Access Compliance Report

Public Rights-of-Way

(Curb Ramps)

Intersection ID: 50602	Main Street: RHODORA_RD	Cross Street: CEDARFIELD_RD	Location: NE
ADA ID: C21D652790EF	Ramp Type: Perp	Initial Pass/Fail: Fail	Overall Compliance: No
Severity Score: 22.5			
Codes/Mitigation Info/Possible Solution		Field Measurements/Component Compliance

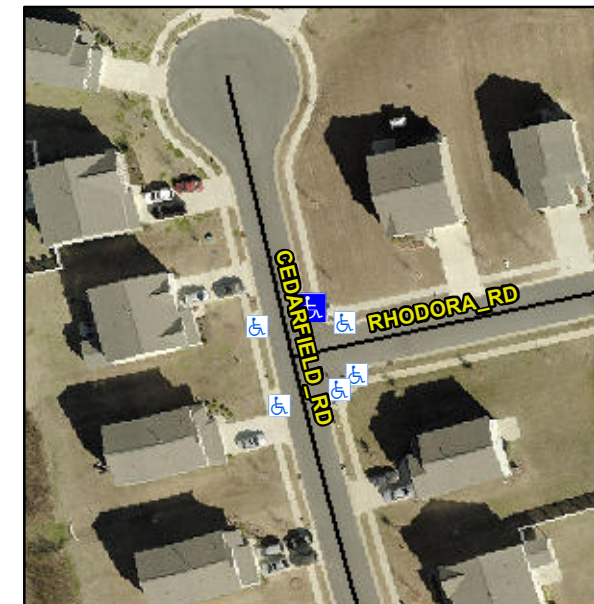
Not Found, R304.5.1, R304.2.2

Compliance	Description	Data	Compliance	Description	Data
N/A	Ramp Length (in)	48.0	No	Ramp Slope (%)	9.5
No	Ramp Width (in)	47.0	Yes	Ramp XSlope (%)	3.4
N/A	Flare Type LT	N/A	N/A	Flare Type RT	N/A
N/A	Flare Slope LT (%)	N/A	N/A	Flare Slope RT (%)	N/A
N/A	Flare Traversable LT?	N/A	N/A	Flare Traversable RT?	N/A
N/A	Landing Length (in)	N/A	N/A	DWS Provided?	N/A
N/A	Landing Width (in)	N/A	N/A	DWS Contrast?	N/A
N/A	Landing Slope (%)	N/A	N/A	DWS Length (in)	N/A
N/A	Landing X Slope (%)	N/A	N/A	DWS Full Width?	N/A
N/A	Landing Curb? (Y/N)	N/A	N/A	DWS Offset (in)	N/A
N/A	Shared Landing?	N/A			
N/A	Gutter Ponding?	N/A	N/A	Gutter Slope (%)	N/A
N/A	Gutter Lip Ht (in)	N/A	N/A	Gutter X Slope (%)	N/A
N/A	Painted X Walk1?	No	N/A	Painted X Walk2?	N/A
	X Walk 1 Direction	To W		X Walk 2 Direction	N/A
N/A	X Walk 1 Width (in)	N/A	N/A	X Walk 2 Width (in)	N/A
	X Walk 1 Slope (%)	2.9		X Walk 2 Slope (%)	N/A
	X Walk 1 X Slope (%)	4.2		X Walk 2 X Slope (%)	N/A

Remove & Replace Entire Ramp.
